**CITY OF CHARLOTTESVILLE
BOARD OF ARCHITECTURAL REVIEW
STAFF REPORT
August 16, 2022**

Discussion (Historic Conservation District)

612 Locust Avenue
Tax Parcel 510039000
Martha Jefferson HC District
Owner/Applicant: Pat Rannigan
Project: Shed/Garage demolition

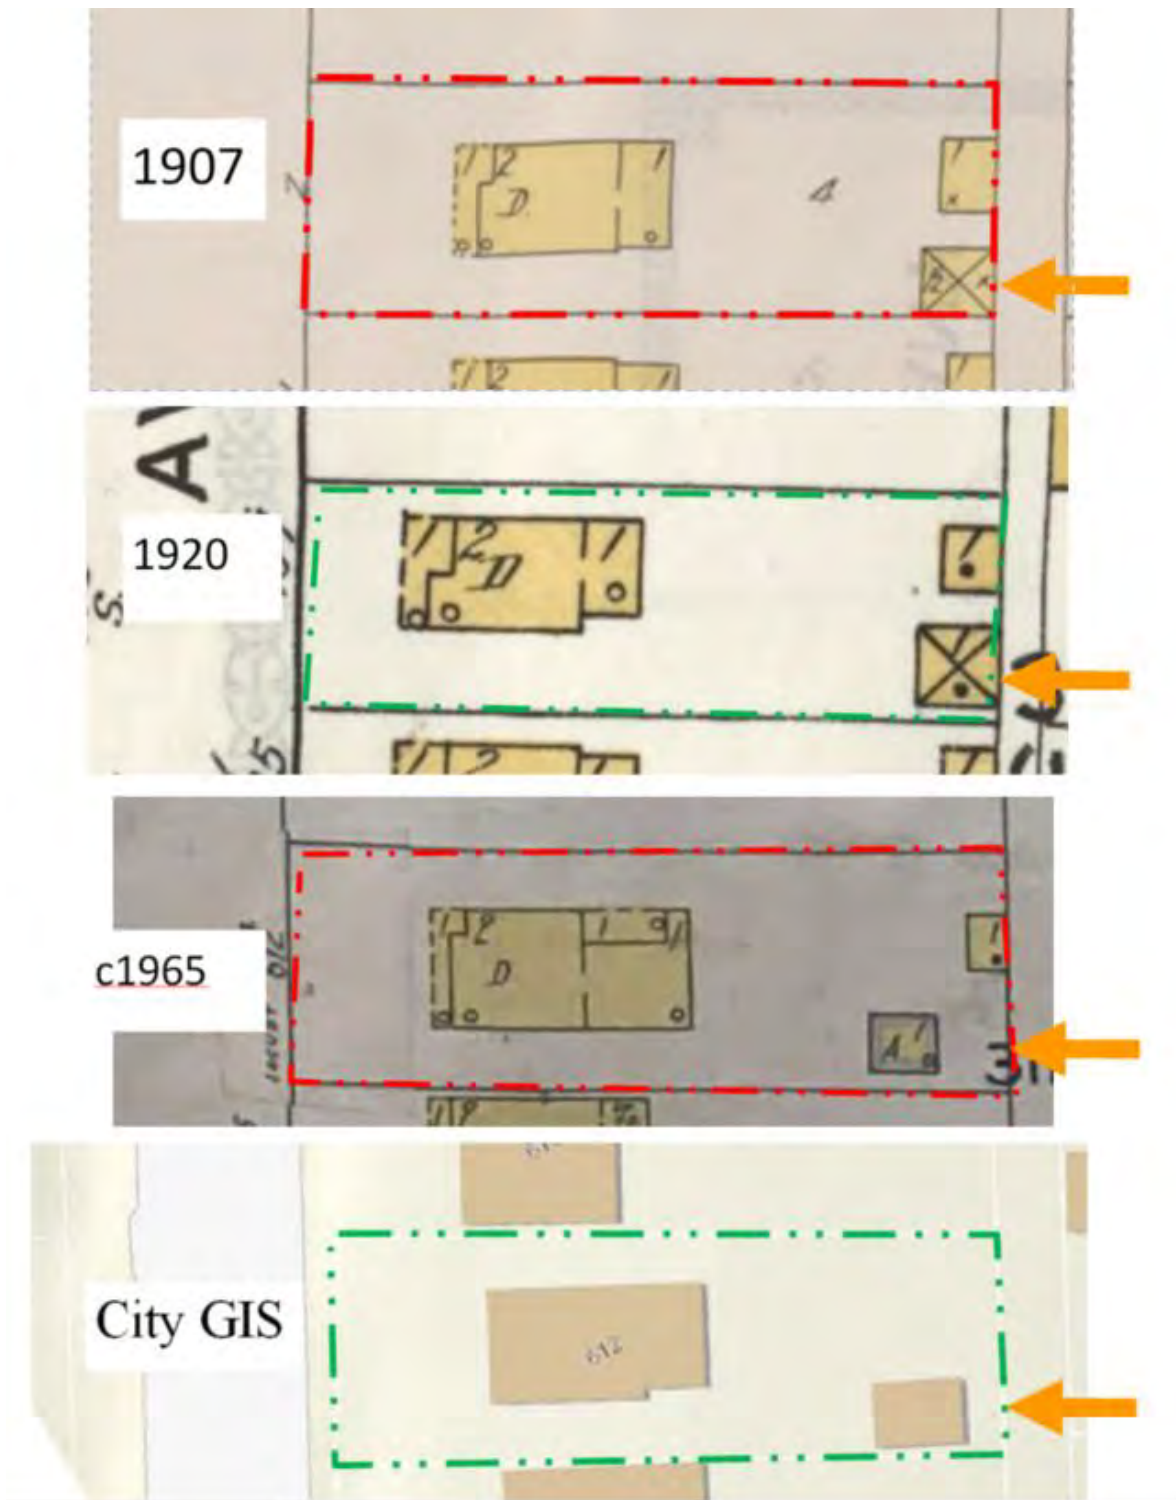
Staff comment: The plywood doors and the metal sheathing are weathered and damaged, some sections of the metal are corroded. The wood framing and metal roofing are significantly deteriorated.

Staff comment: The applicant has provided photos that illustrate the deteriorated condition of the existing garage/shed.
